# **Assessment of Pacific Gas & Electric Company's Pipeline Safety Enhancement Plan**

**Prepared For  
Consumer Protection & Safety Division**

**December 23, 2011**

**Figure 5 - PG&E Program Management Organization Structure**

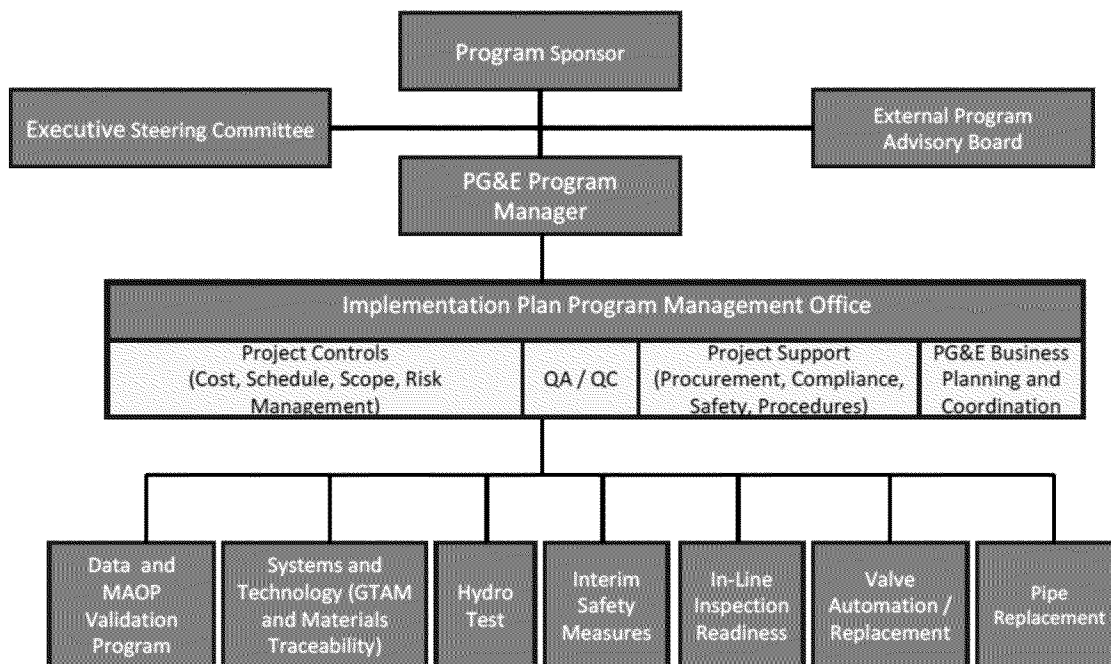
While the specific structure of a program management organization can somewhat vary based on a given program's size, complexity, and client needs, the PG&E program management organization structure, as shown in Figure 2, is consistent with industry practices, as are the roles and responsibilities of the major functions. The major functions of PG&E's programs management organization are:

- The Implementation Plan PMO organizational structure looks to provide a good framework. The organization and governance is based on current industry practices.
